Technical BULLETIN

SAFETY RECALL

CERTAIN 2024 1544LW BOATS FACTORY MODIFICATION CAMPAIGN – Starboard Level Flotation Compliance

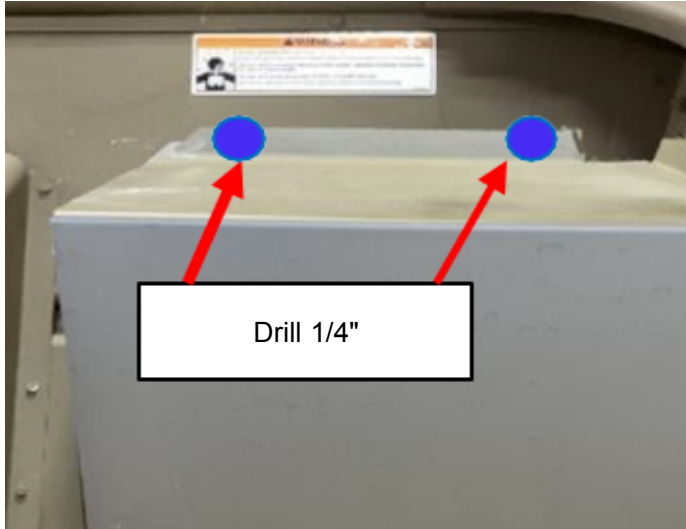
4. On the starboard side rear of the boat, place the 11" x 11" x 6-1/2" foam piece (P/N: 895371) against the side of the hull and the 13" x 9-1/2" x 4" foam piece (P/N: 895372) next to it.

5. Place the pre-assembled starboard pod into place over the foam piece.

6. Remove the "Rotating Propeller" Warning Label (P/N: 73409047) before pod installation. Be sure to remove all label residue. Install the replacement label to the left of the CO Warning Label after thoroughly cleaning the area.

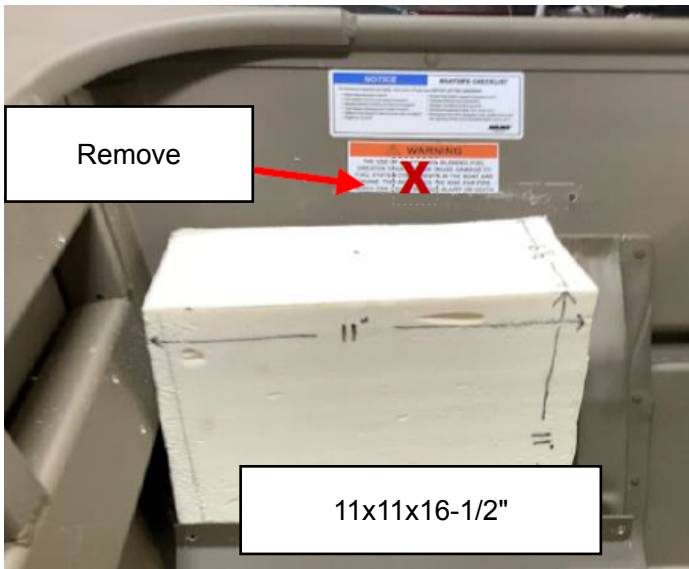
7. Make sure the starboard pod is squared up properly before securing it into place. Drill two #7/16" holes (in the areas represented by the blue dots below).

8. Next, insert the bolts from the outside of the hull and then tighten down the bolts with a 7/16" wrench.

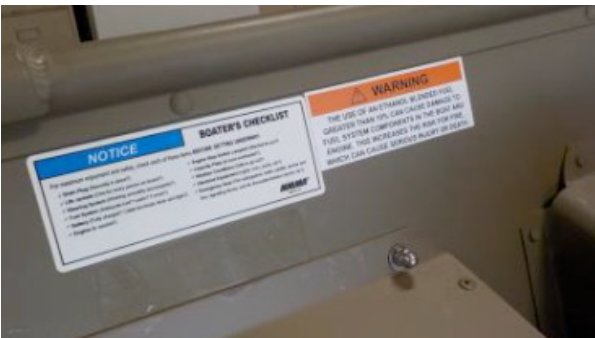
10. Drill holes with a #11 drill bit into the pod and fill with the AS66SS Olive pop rivets using a pop rivet gun (white dots below represent placement of the pop rivets).

11. On the port side rear of the boat, place the 11" x 11" x 6-1/2" foam against the port side of the hull.

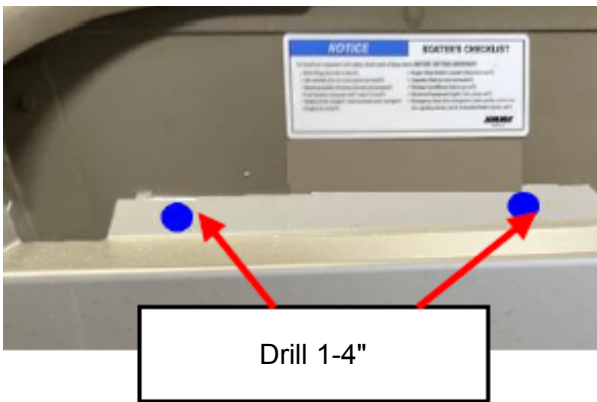
12. Remove the "Ethanol" Warning Label (P/N: 73409043) before attaching the pod. Be sure to remove all label residue. Install the replacement label from the kit to the right of the Boater's Checklist label after thoroughly cleaning the area.

13. Place the port pod into place over the foam. Make sure the port pod is squared up properly before securing it into place.

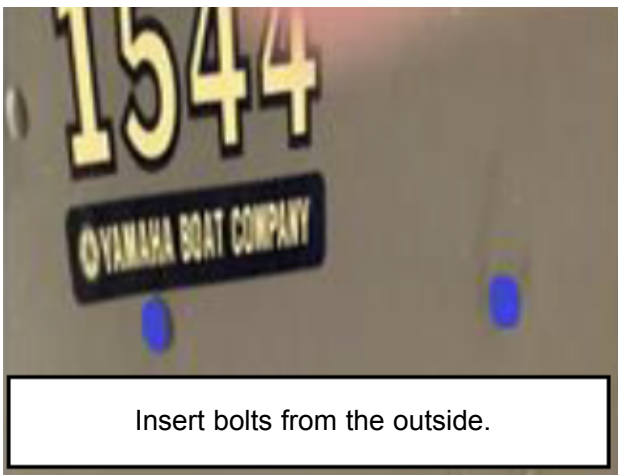
14. Drill two 7/16" holes (blue dots below represent drill location).

15. Next, insert the bolts from the back side of the hull (blue dots below represent bolt locations). Tighten down with a 7/16" wrench.

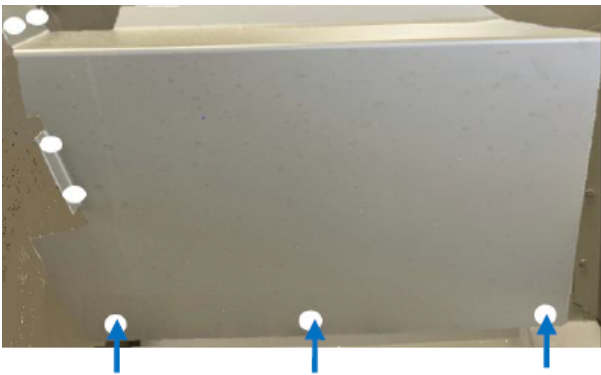
17. Drill holes using a #11 drill bit and fill with AS66SS Olive pop rivets using a pop rivet gun (white dots represent placement of pop rivets).
